ADDENDUM #2

NORTH TRUCKEE DRAIN REALIGNMENT PHASE 1

BID #13/14-007 – PWP# WA-2014-011

This addendum is to notify all potential proposers of clarifications made to the Bid documents as stated below.

SHEET No
G-3
SHT OF

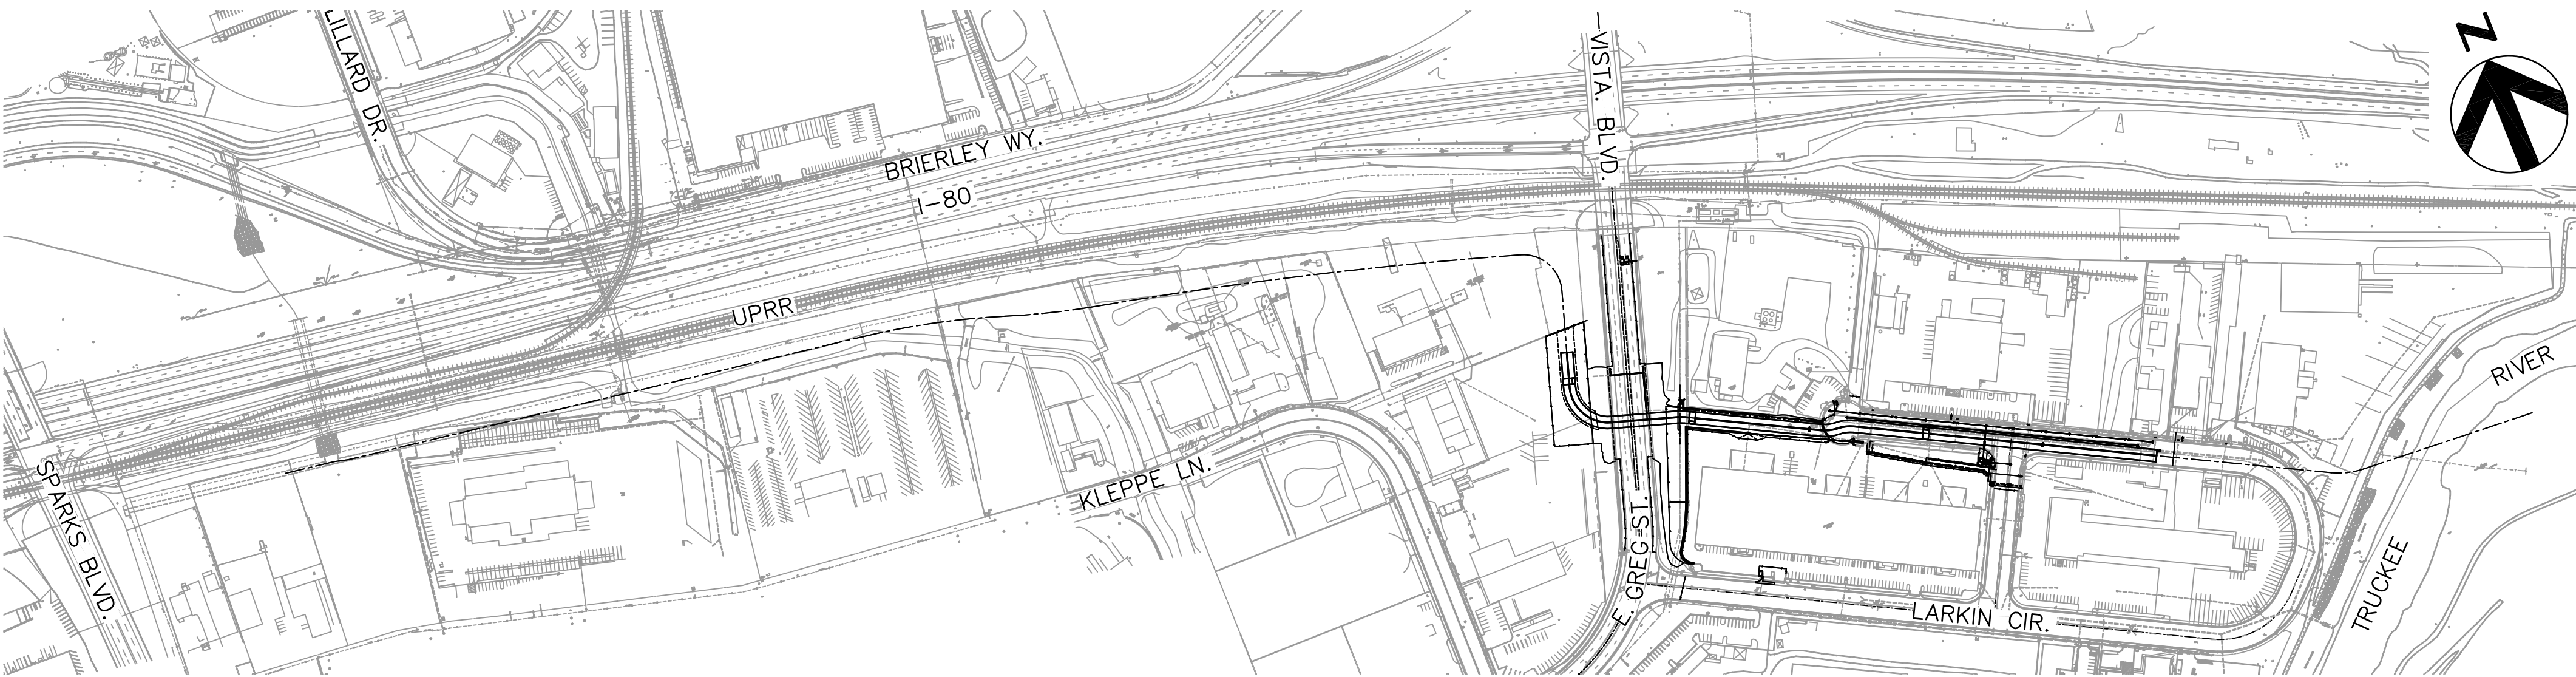
1. Sheet G-3 – Note 13 – Note is no longer applicable and was deleted.
2. Sheet HC -1 – Crown Curve Table was added to the bottom center of the sheet.
3. Sheet HC - 3 – Crown line and callout were added to the sheet.
4. Sheet HC-4 – Stationing was changed at eight station and offset callouts at the following offsets:

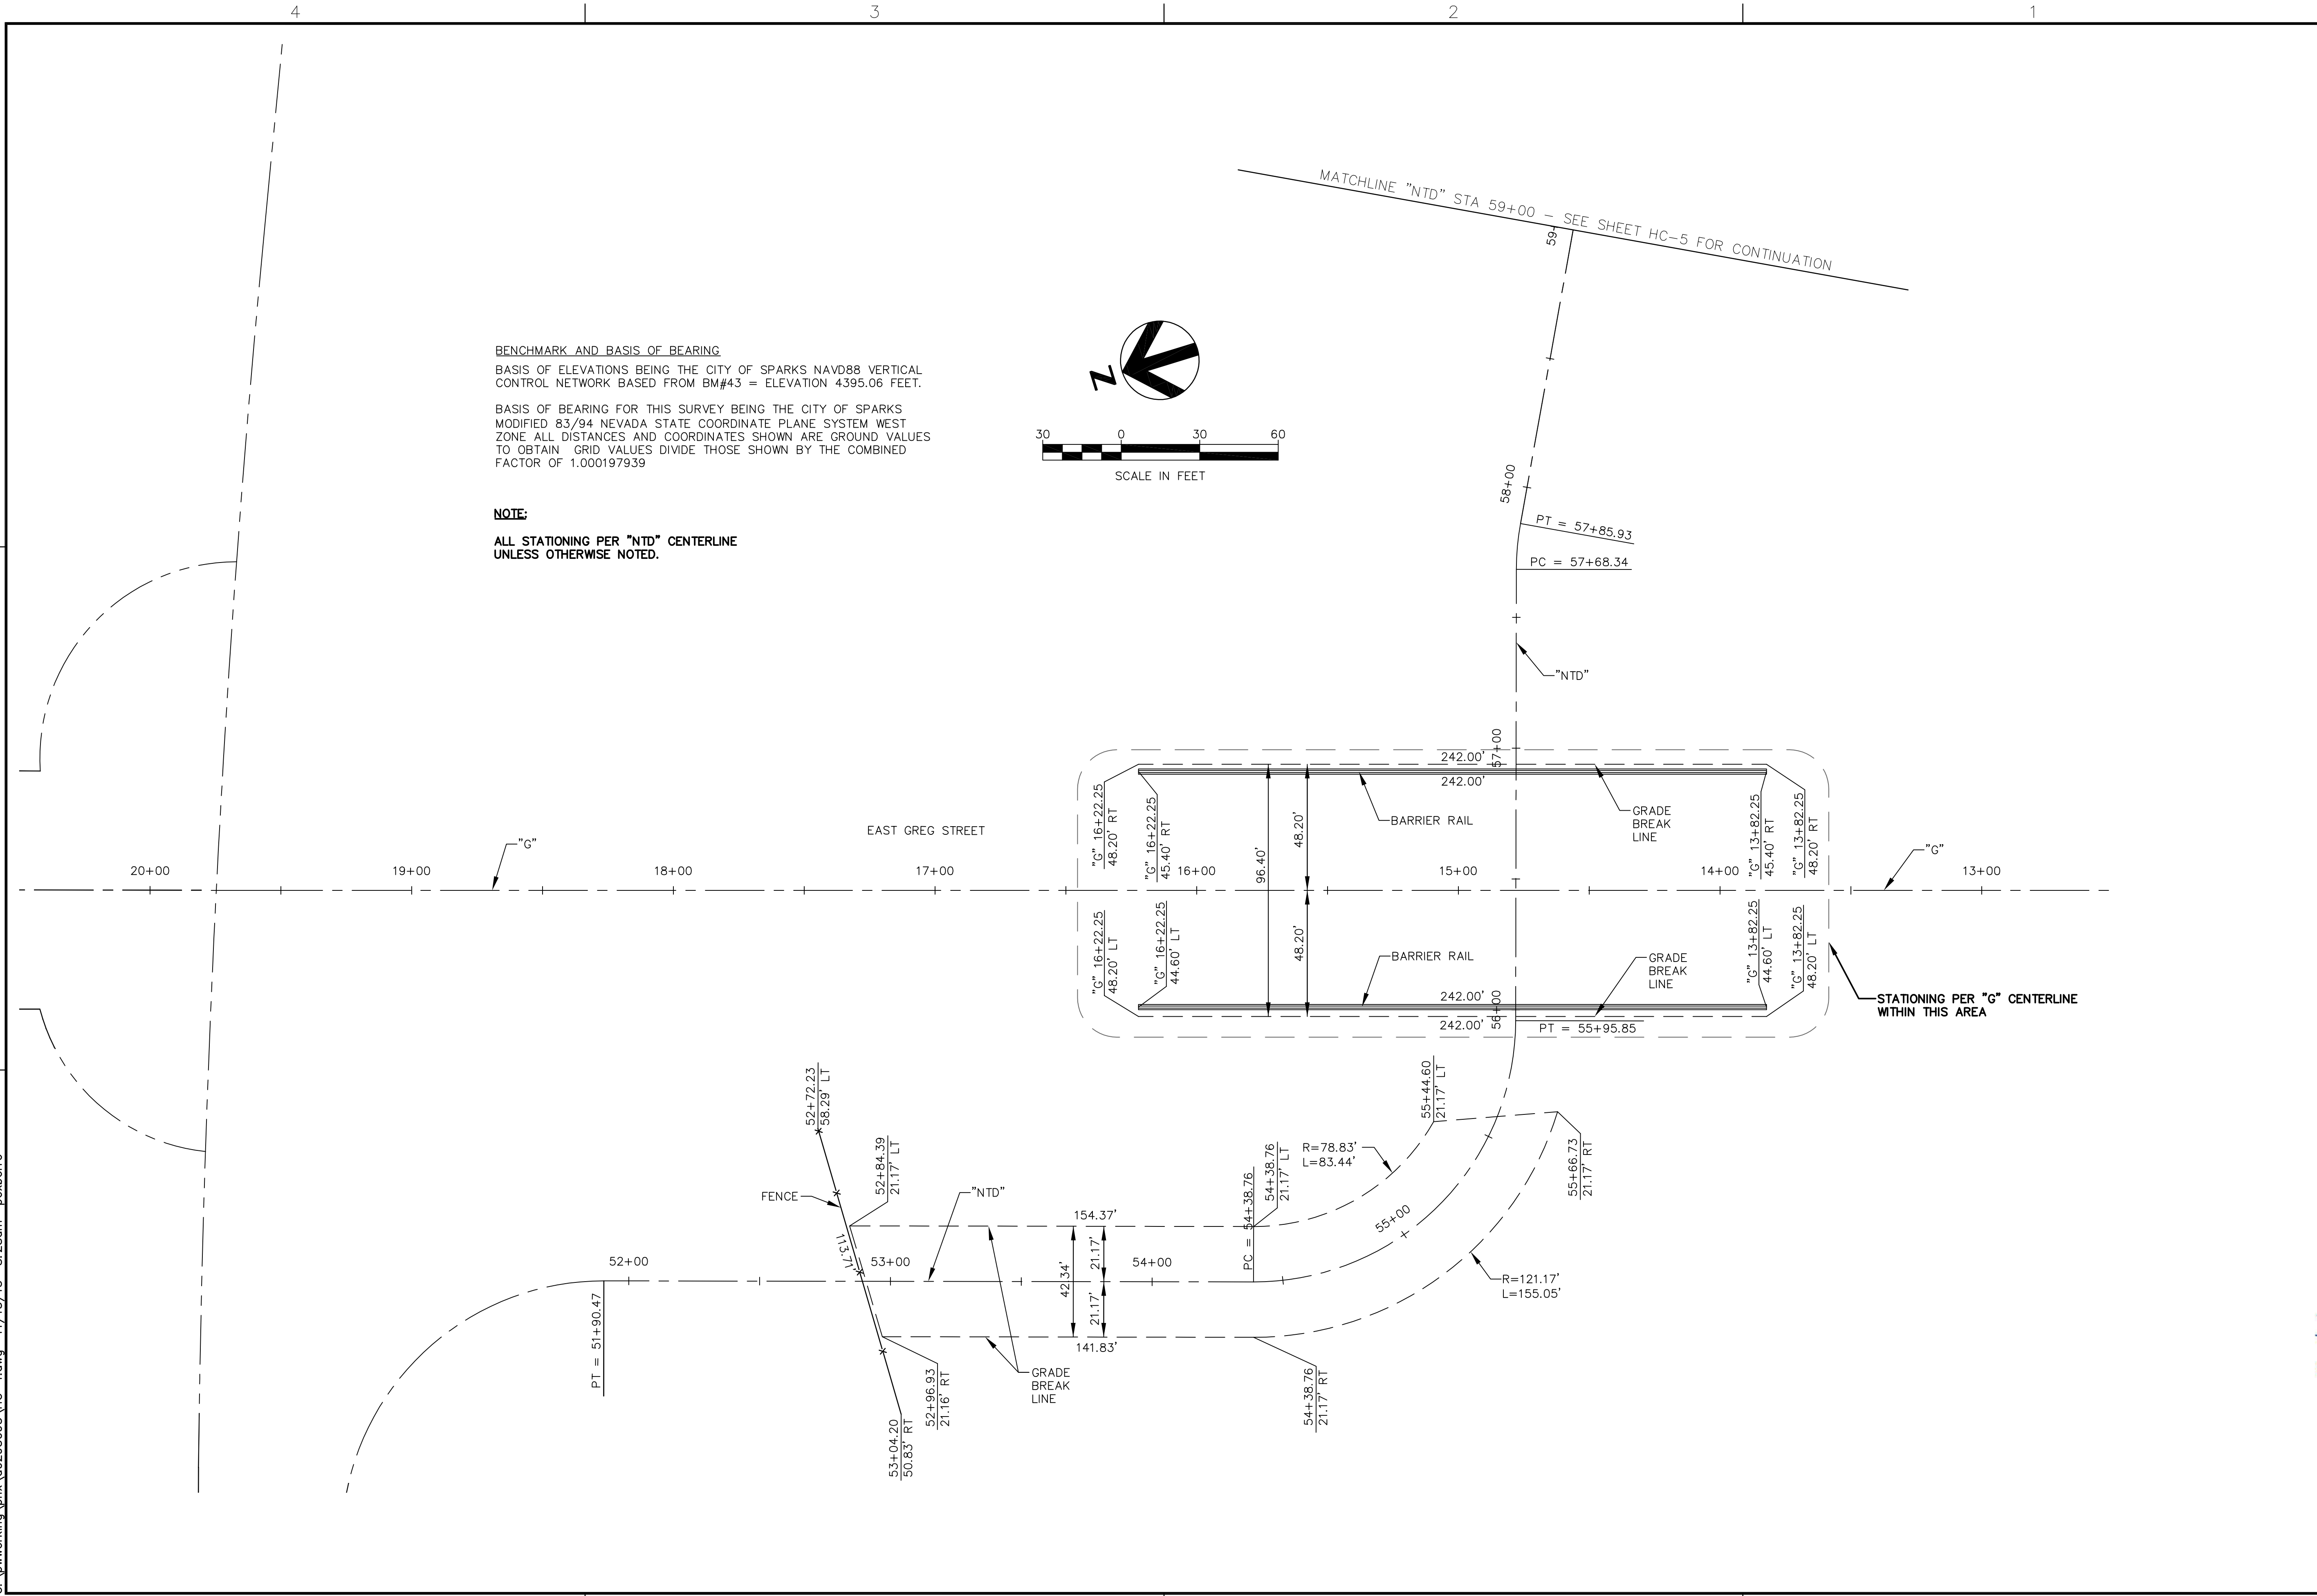
- a. "G" 16+20.00 was changed to "G" 16+22.25 at 48.20' LT and RT and 44.60' LT and 45.40' RT
 - b. "G" 13+78.00 was changed to "G" 13+82.25 at 48.20' LT and RT and 44.60' LT and 45.40' RT

<p>DESIGNED BY: PEO DRAWN BY: PEO CHECKED BY: NL APPROVED BY: NL SCALE: 1"=40' HORIZ: N/A VERT: N/A</p>	<p>REV No DATE DESCRIPTION</p>
<p>NORTH TRUCKEE DRAIN REALIGNMENT PHASE 1</p> <p>DEMOLITION PLAN "NTD" STA 52+50 TO STA 61+00 "G" STA 9+50 TO STA 20+00</p>	
<p>SHEET NO D-2</p>	
<p>SHT OF</p>

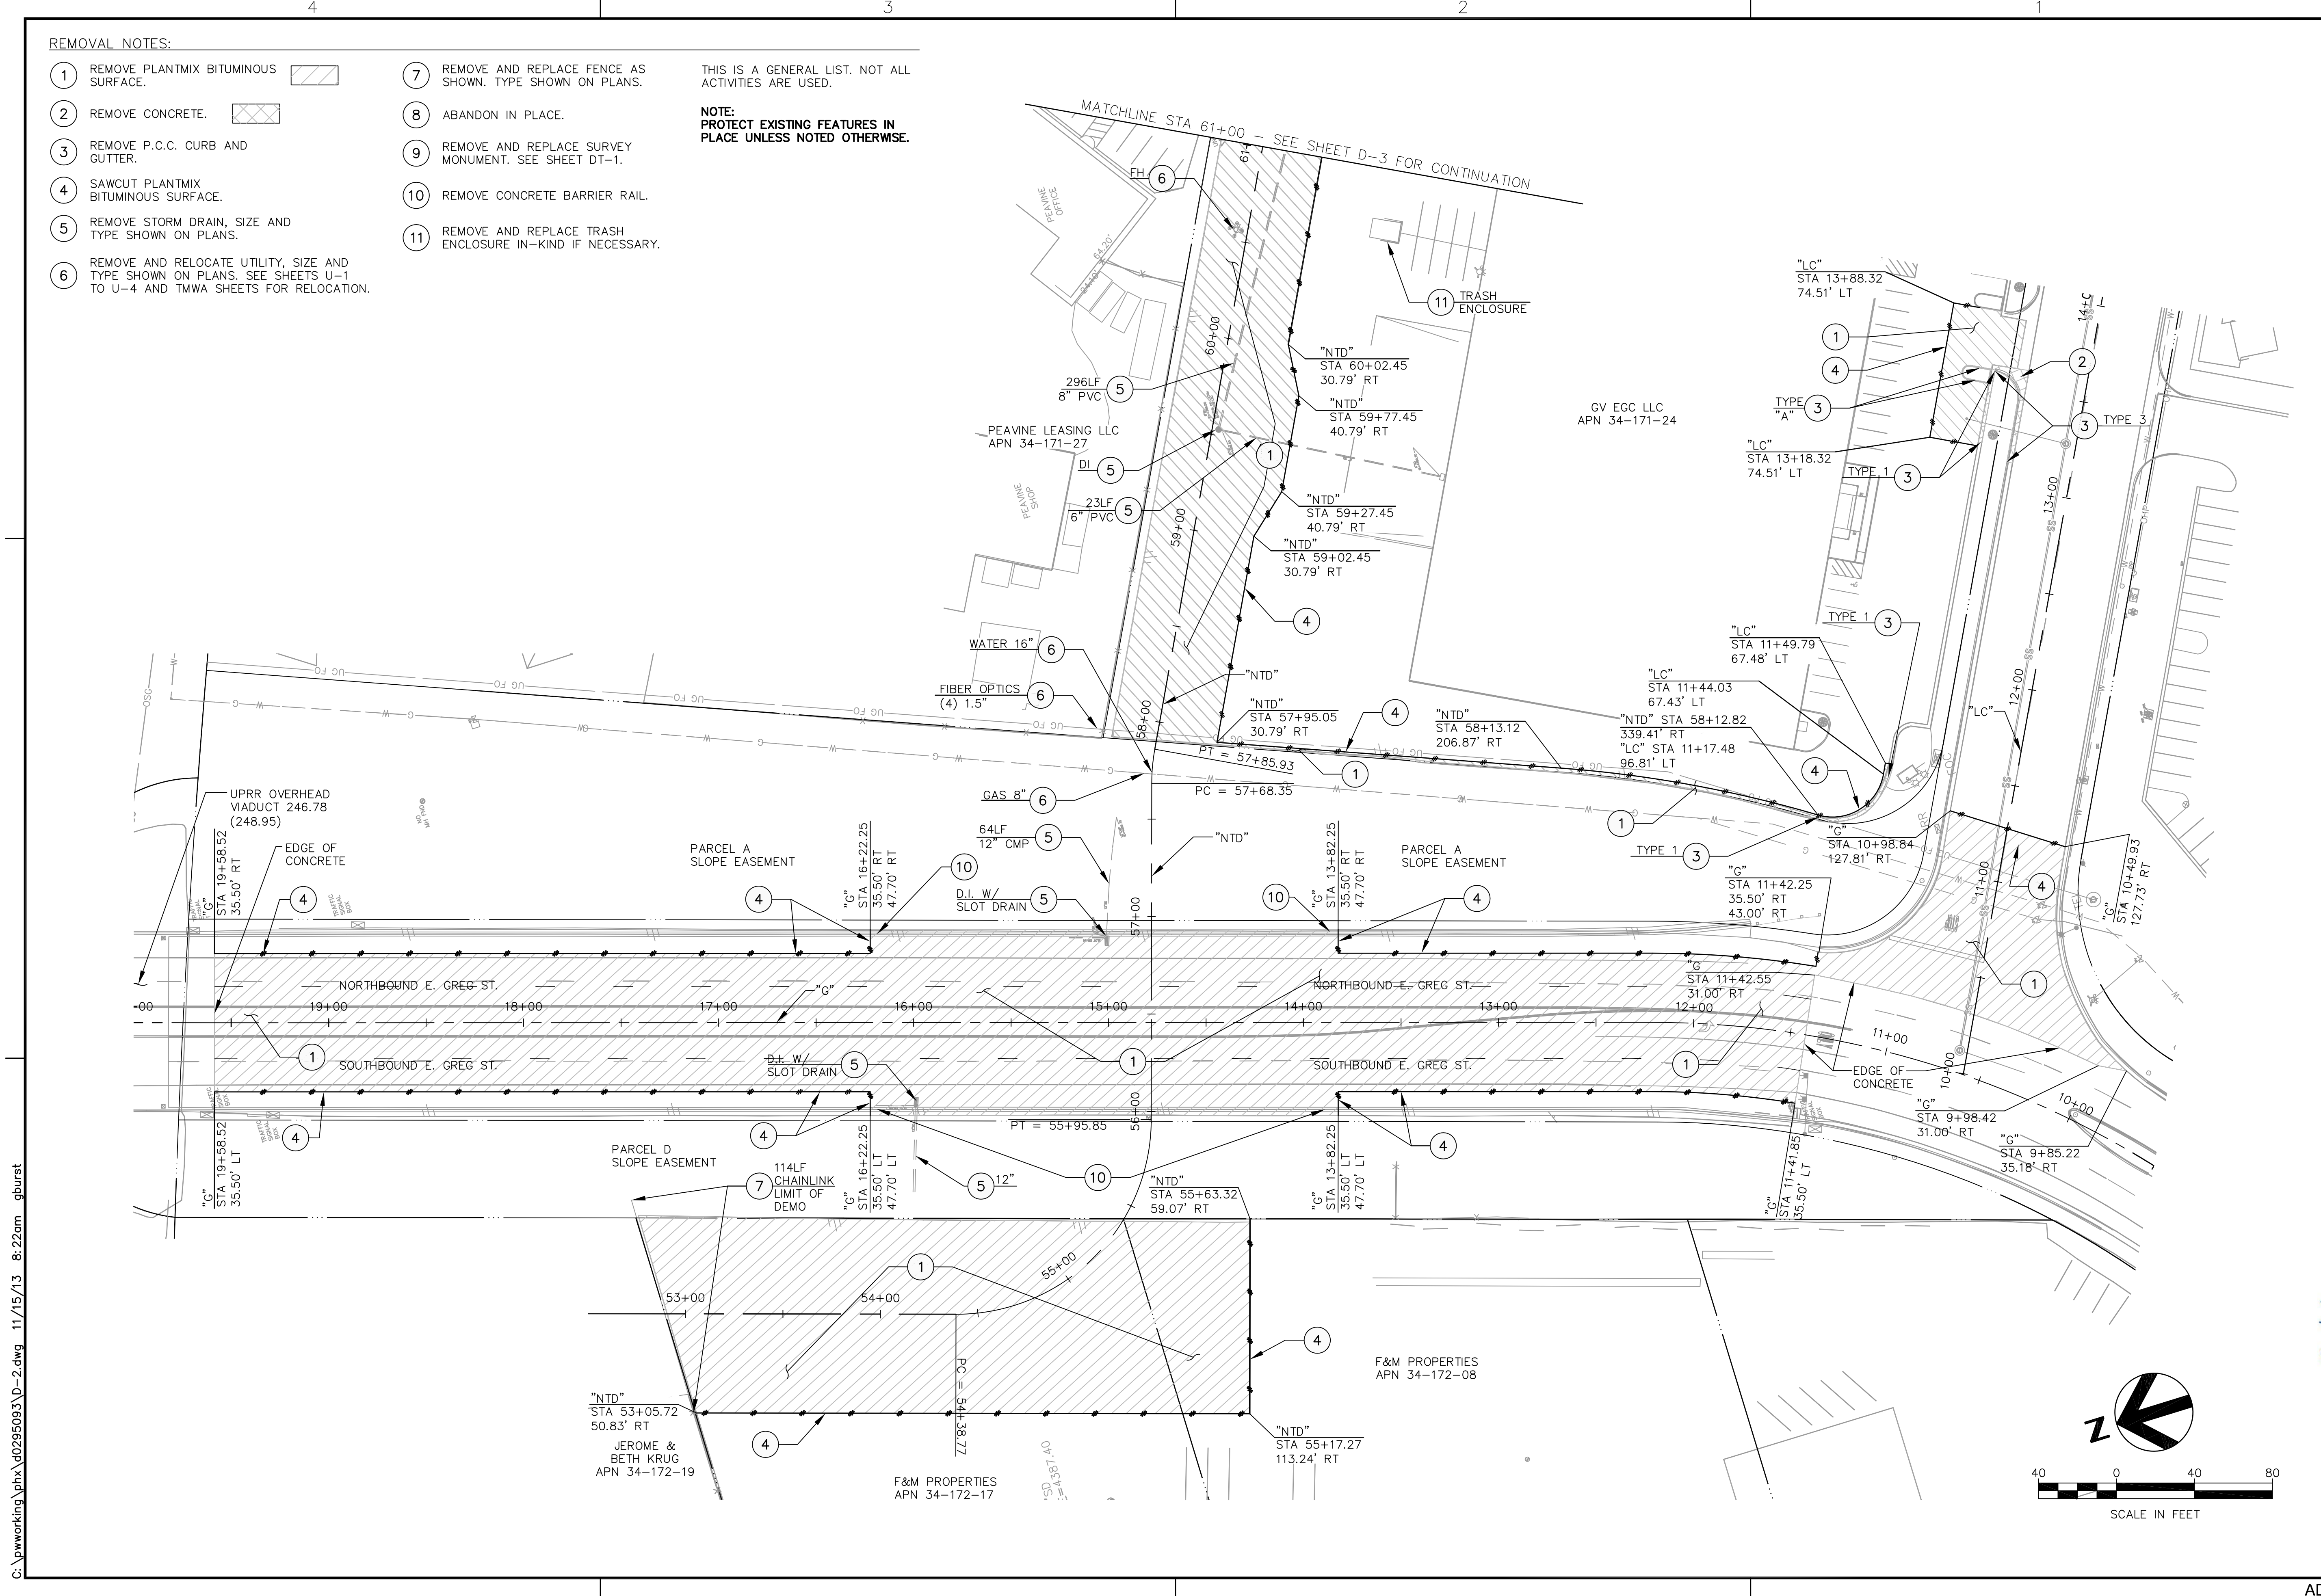
5. Sheet D-2 – Station and offsets were changed at six locations:
 - a. "G" 16+20.00 was changed to "G" 16+22.25 at LT and RT
 - b. "G" 13+78.00 was changed to "G" 13+82.25 at LT and RT

- c. "G" 10+97.47 104.98' RT was changed to "G" 10+98.84 127.81' RT
 - d. "G" 10+47.79 112.79' RT was changed to "G" 10+49.93 127.73' RT
6. Sheet C-5 – Top of grate elevations for drop inlets updated throughout the sheet.
